ILLUSTRATIVE SITE DESIGNS
FOR
MULTI-FAMILY HOUSING IN PASADENA

Prepared for the Pasadena
Multi-Family Housing Task Force

Daniel Solomon and Associates
Daniel Solomon
Kathryn Clarke
Susan Haviland

DSA 48.10

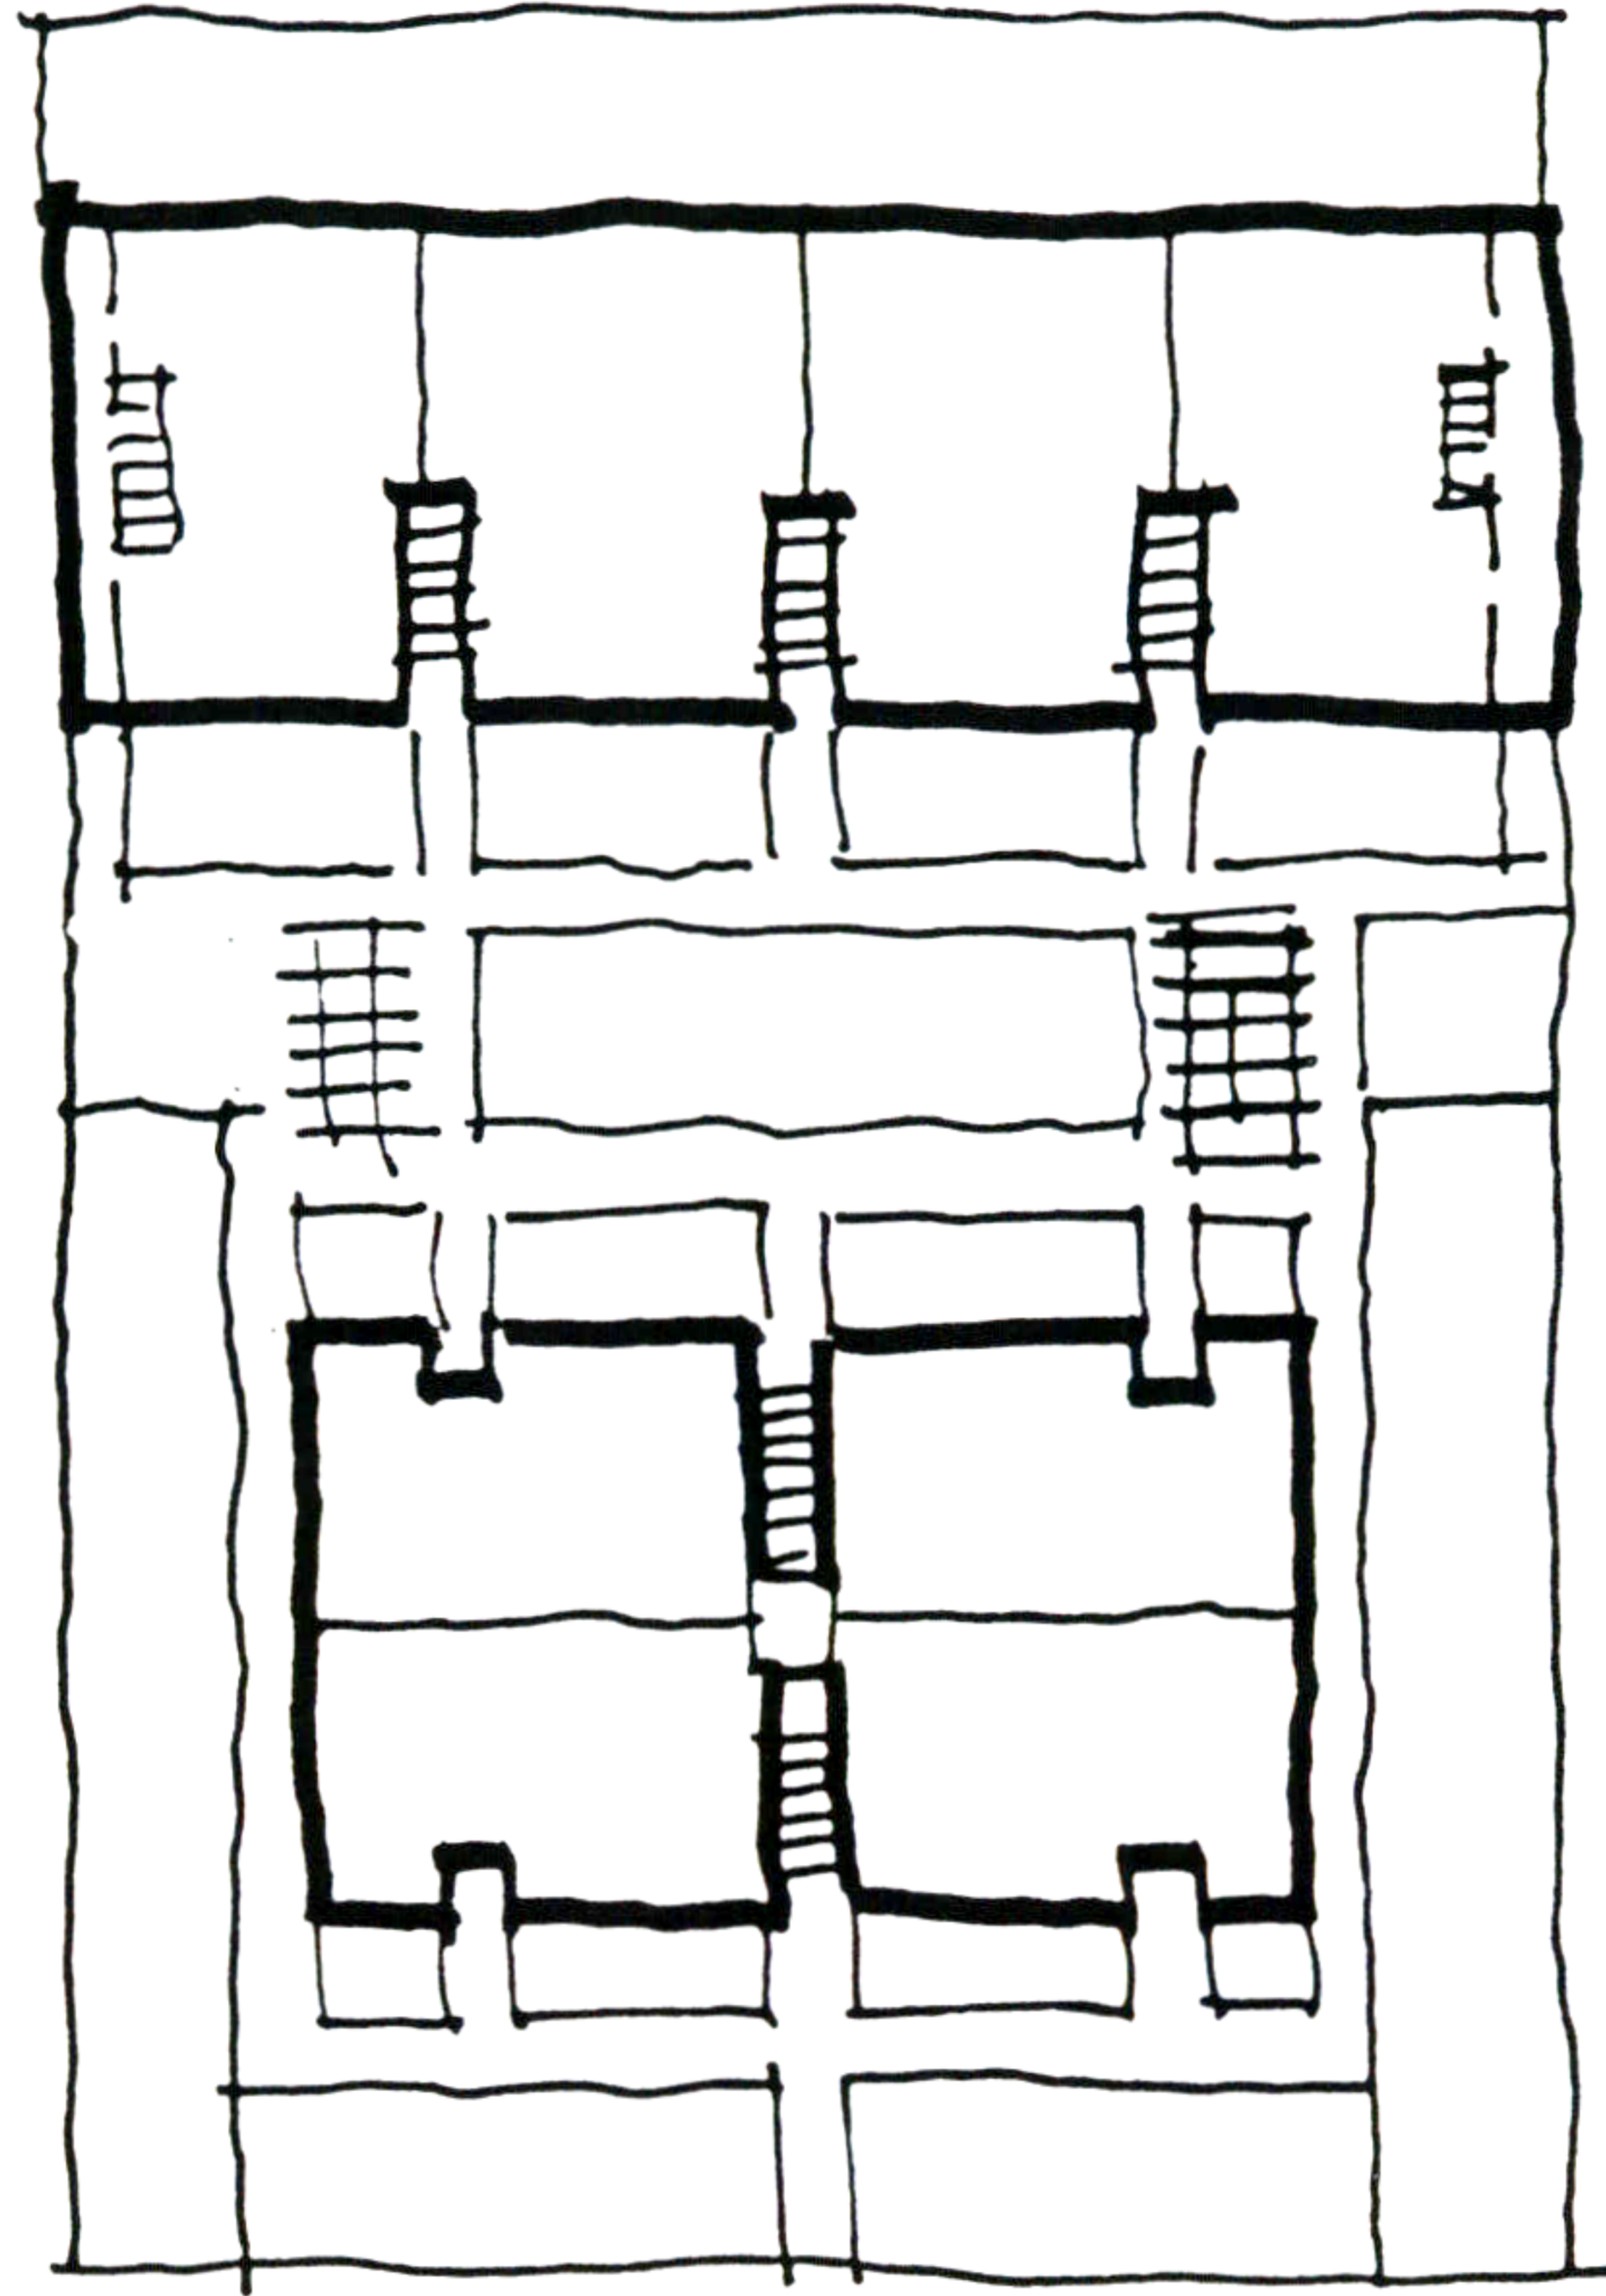
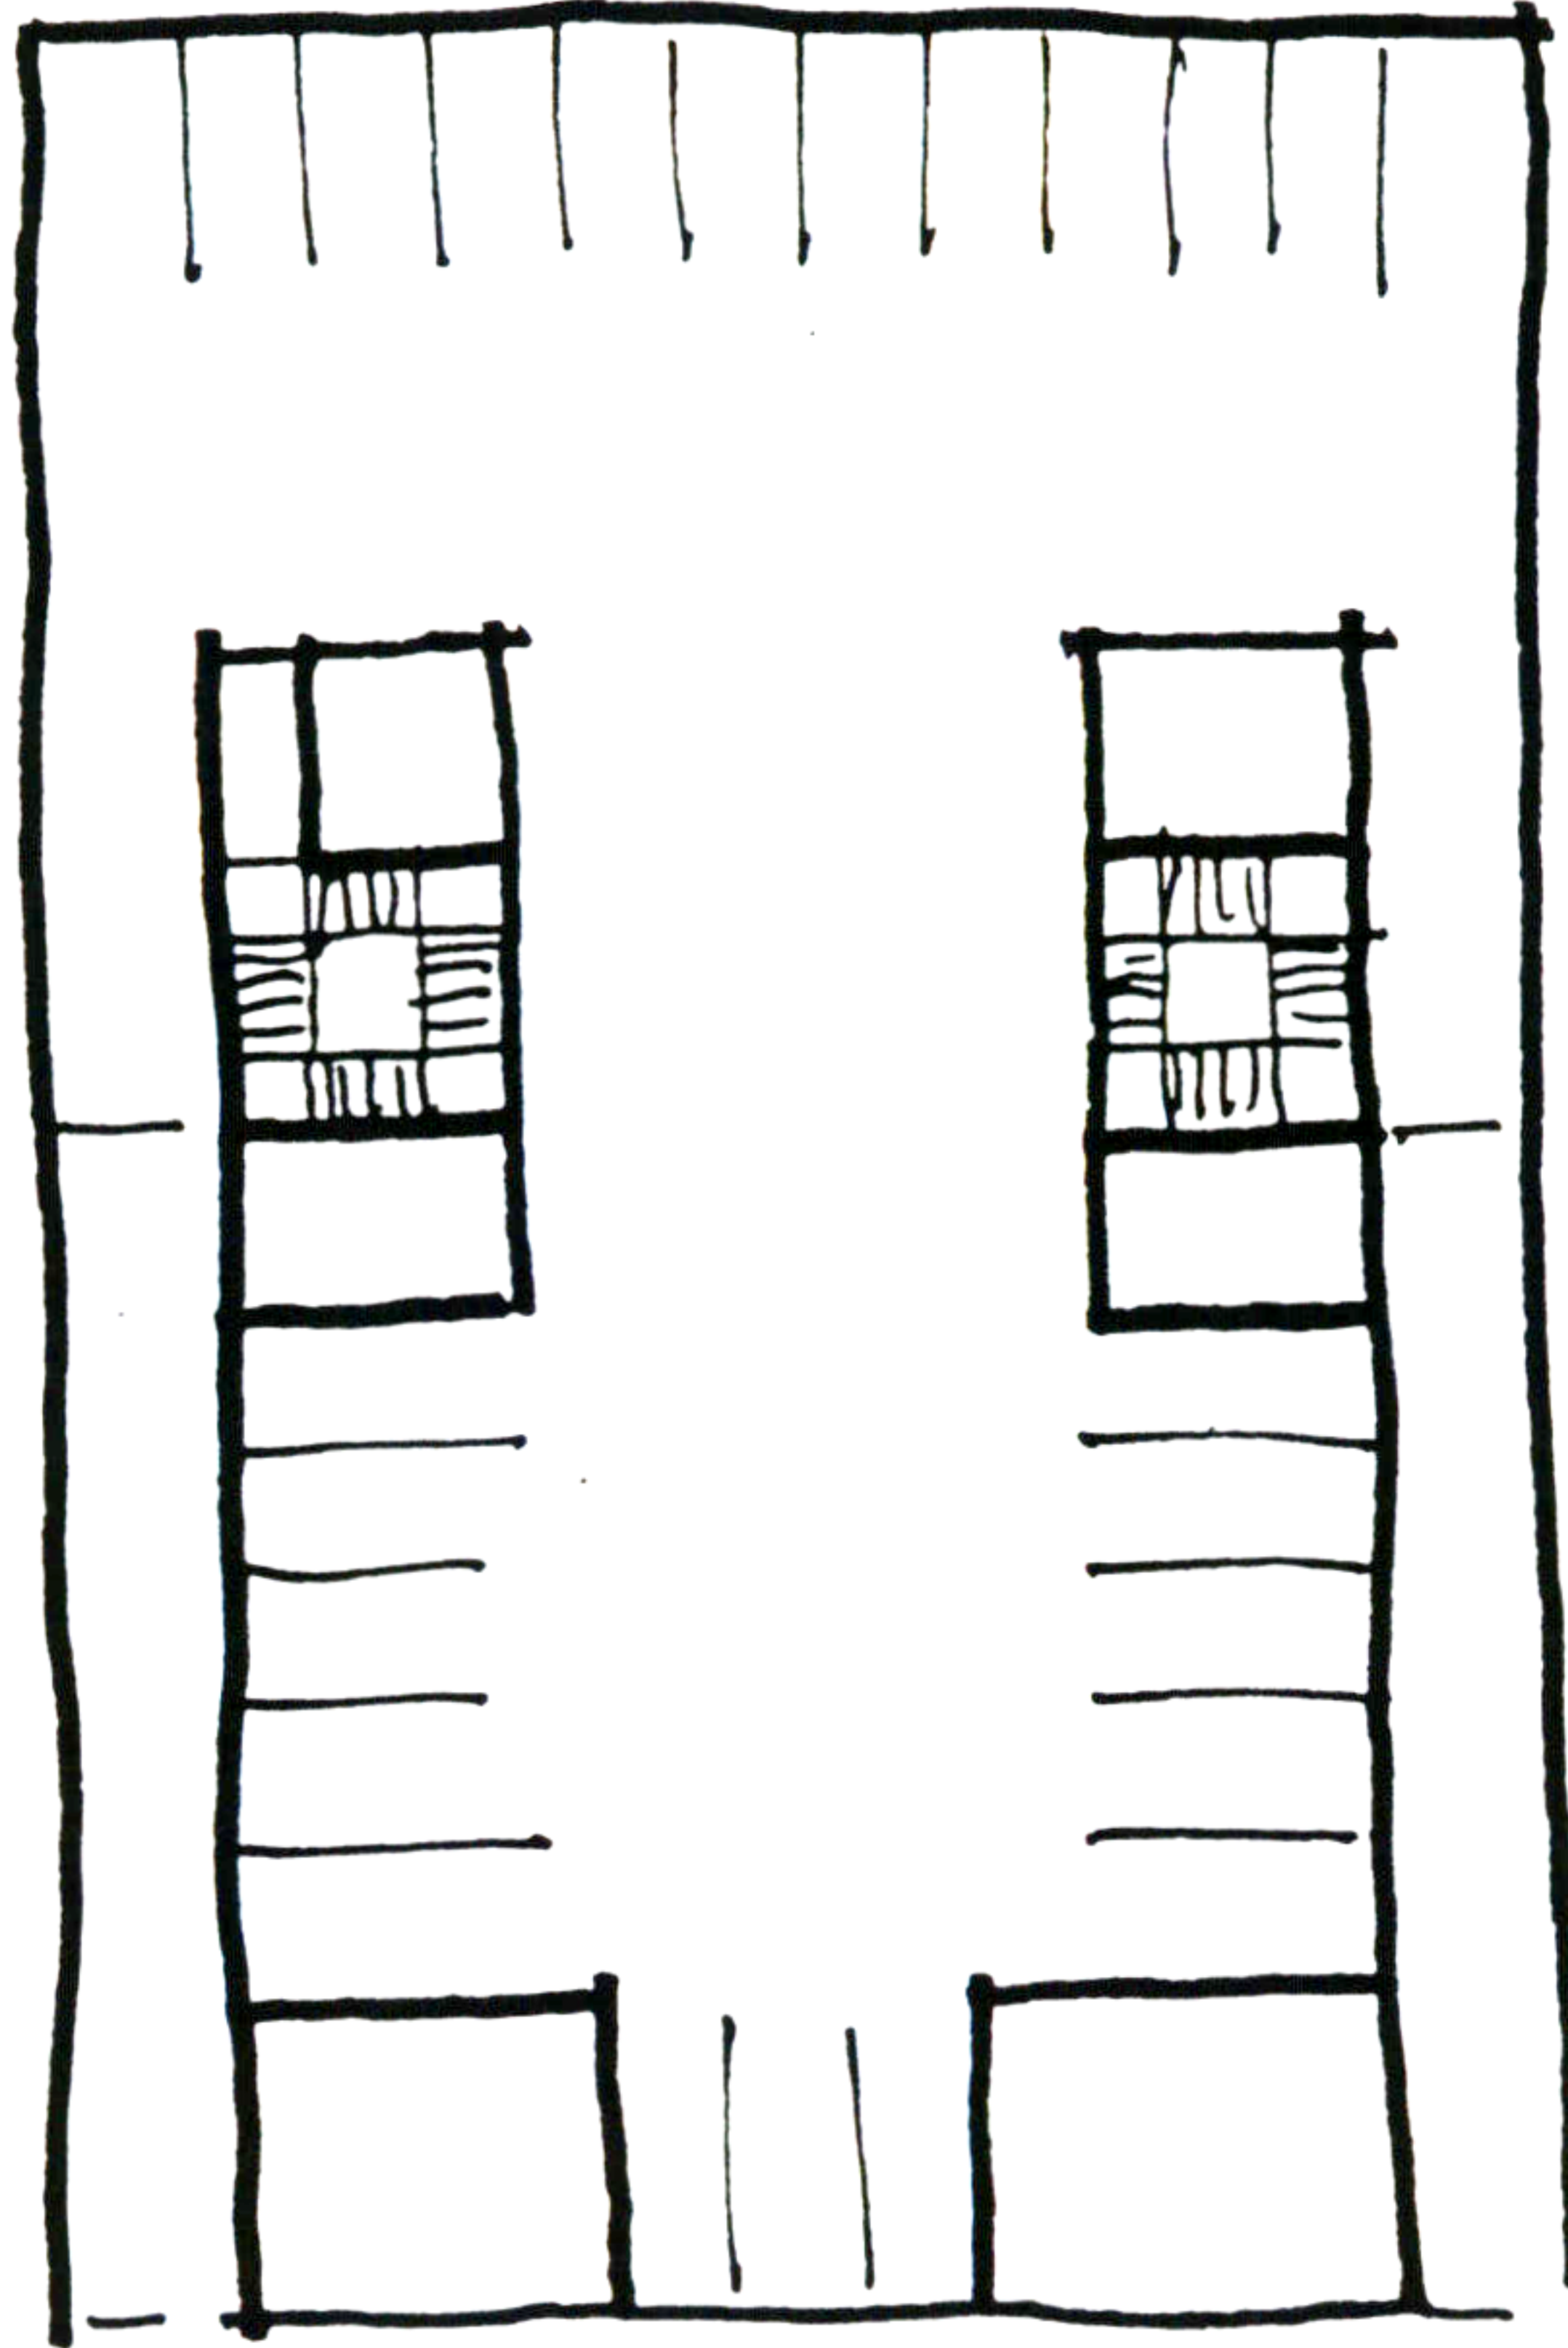
Case Study No:	DSA 48.10
Density Zone:	RM. 48
Type of Parking:	Fully Subterranean
Comments:	Not acceptable
Lot Size:	100' x 154'
Lot Area, S.F.:	15,400 #
Lot Area, Acres:	.35 acre
Units:	8 2BR townhouses, 4 1BR apts 12 Total
DU per Acre:	34
Range:	
FAR:	1.02
<u>Parking</u>	
Provided:	25 spaces
Required @,	
2 to 1:	24
1.5 to 1:	18
1 per BR:	20
1.5 and 2:	22
<u>Open Space</u>	
Main Garden:	3,000 #
Front Yard:	1,920
Subsidiary:	1,000
Total:	5,920 #

DSA 48.11

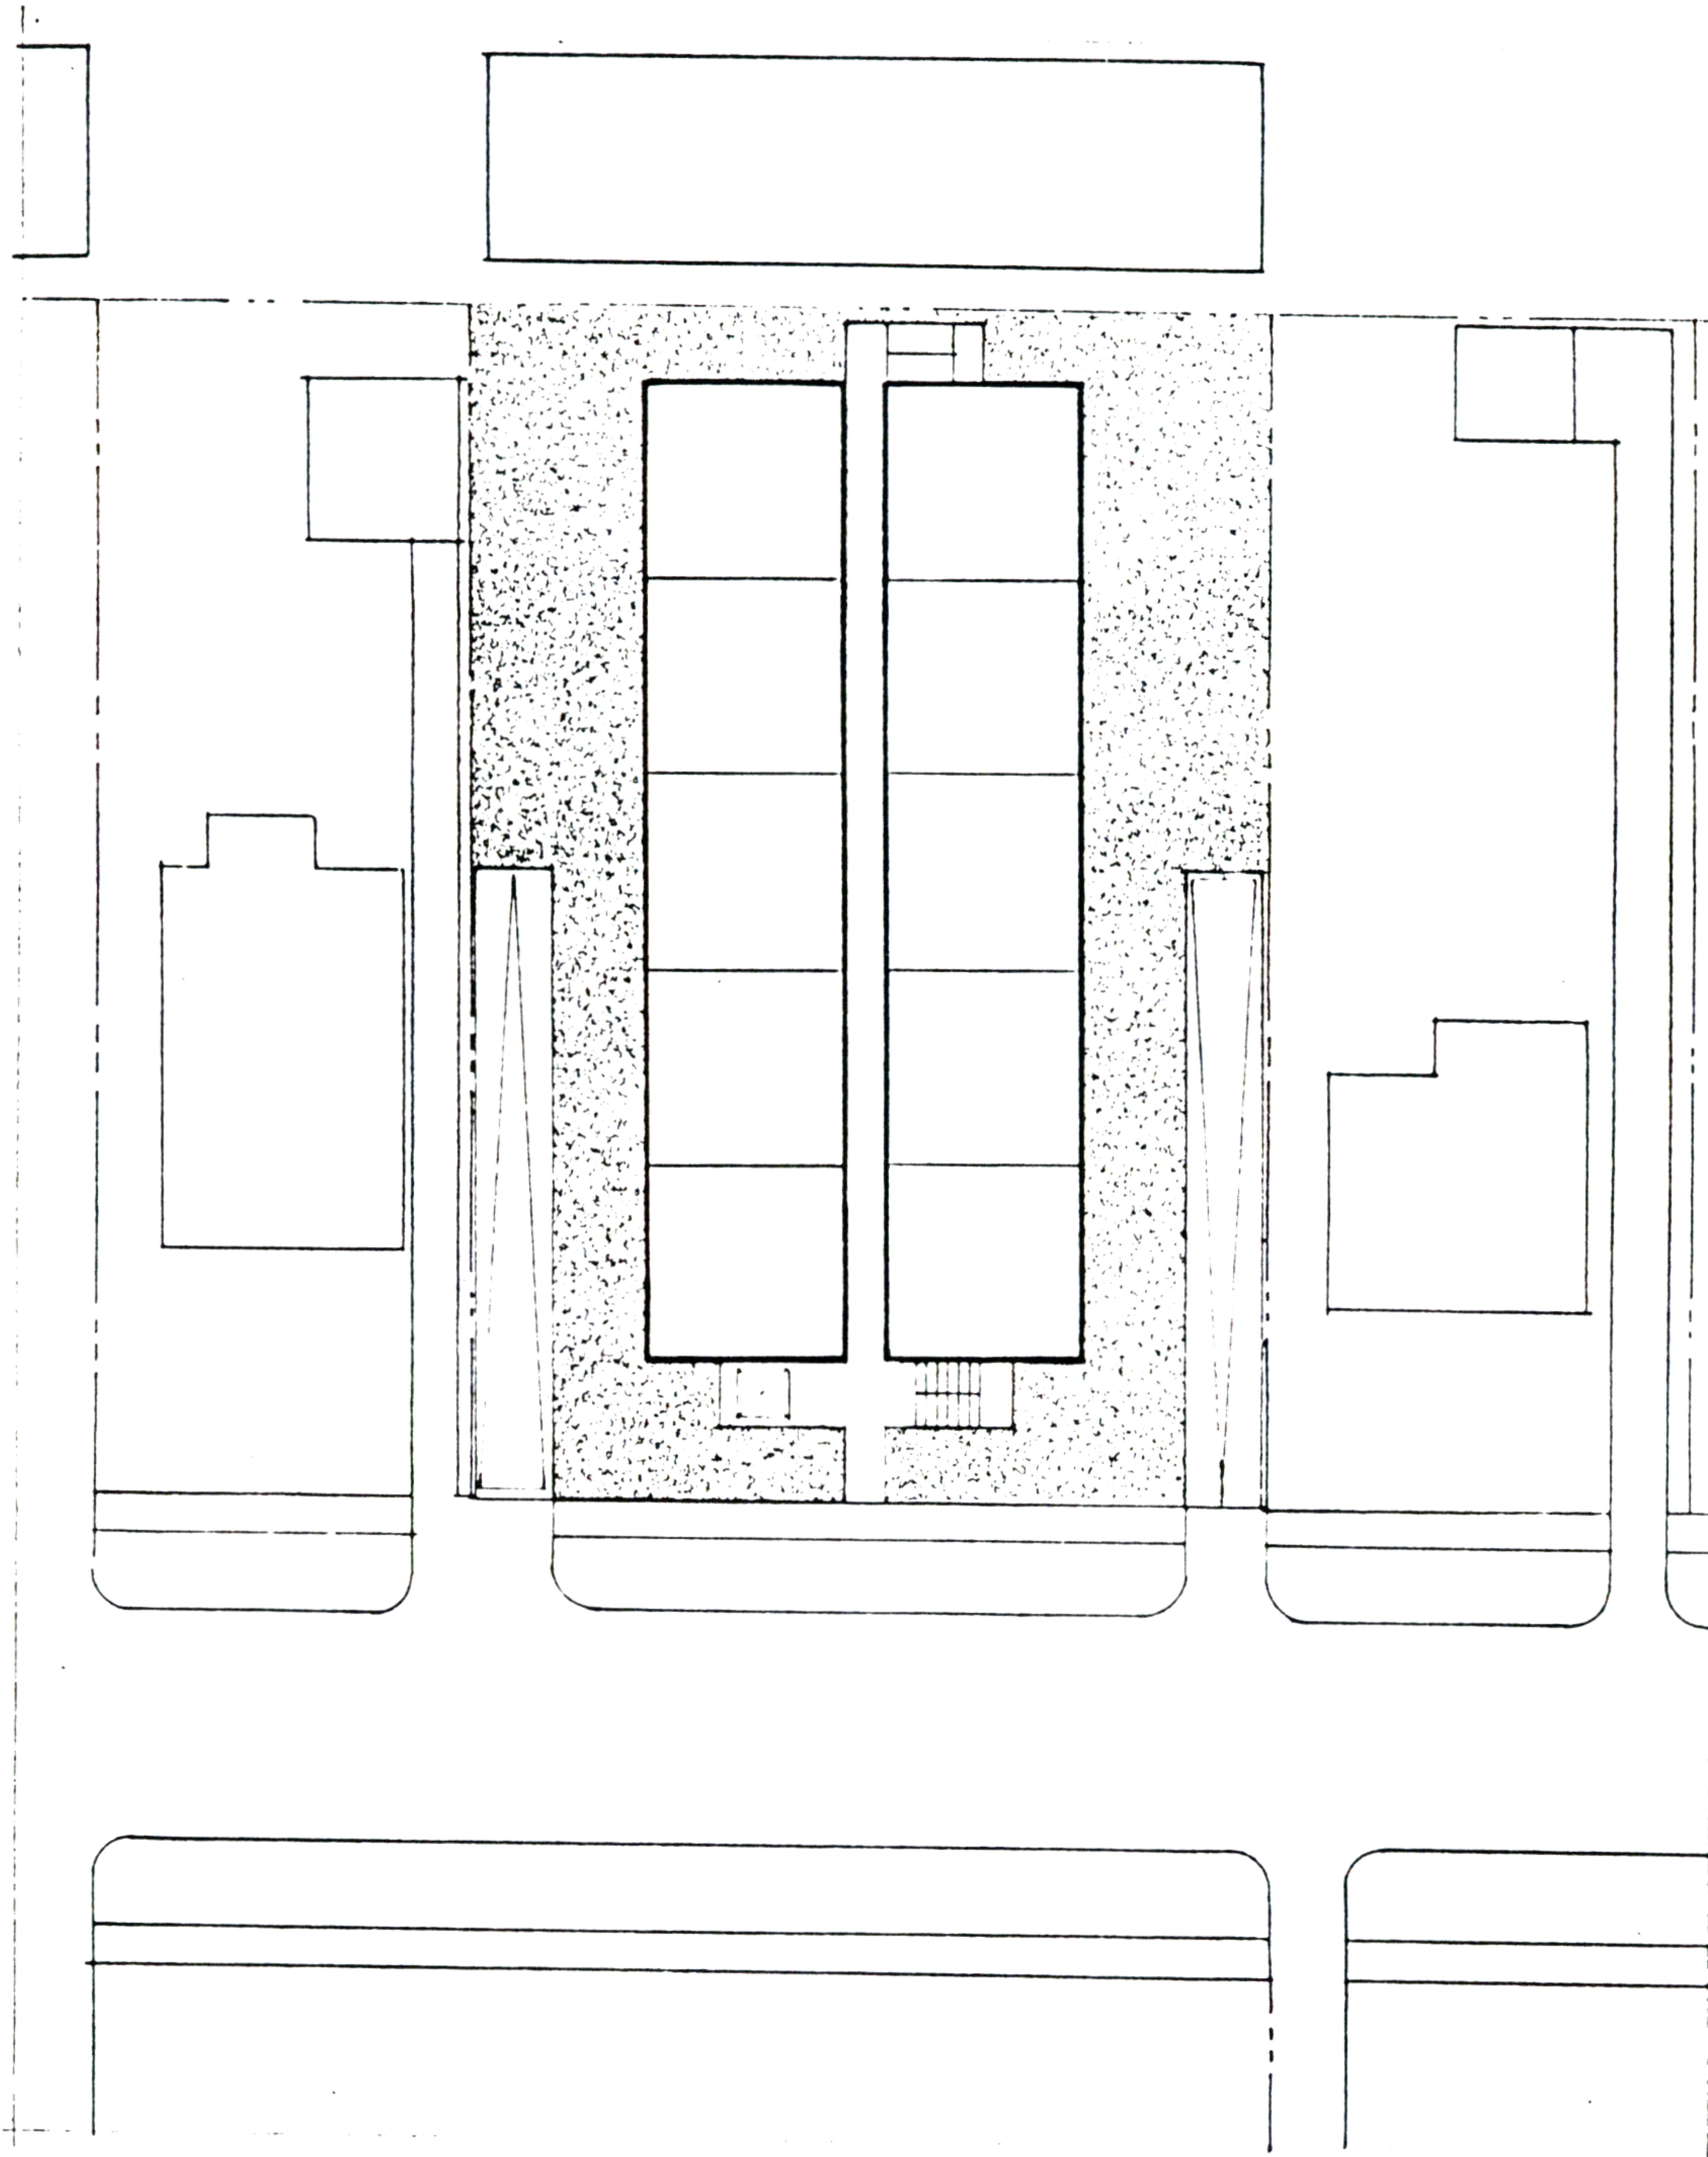
Case Study No:	DSA 48.11
Density Zone:	RM-40
Type of Parking:	Fully Subterranean
Comments:	Not Acceptable Scheme
Lot Size:	100' x 154'
Lot Area, S.F.:	15,400 #
Lot Area, Acres:	.35 acre
Units:	10 2BR duplex apts. 10 1BR apts. 20 total
DU per Acre:	57
Range:	
FAR:	1.12
<u>Parking</u>	
Provided:	
Required @,	
2 to 1:	40
1.5 to 1:	30
1 per BR:	30
1.5 and 2:	35
<u>Open Space</u>	
Main Garden:	none!
Front Yard:	
Subsidiary:	
Total:
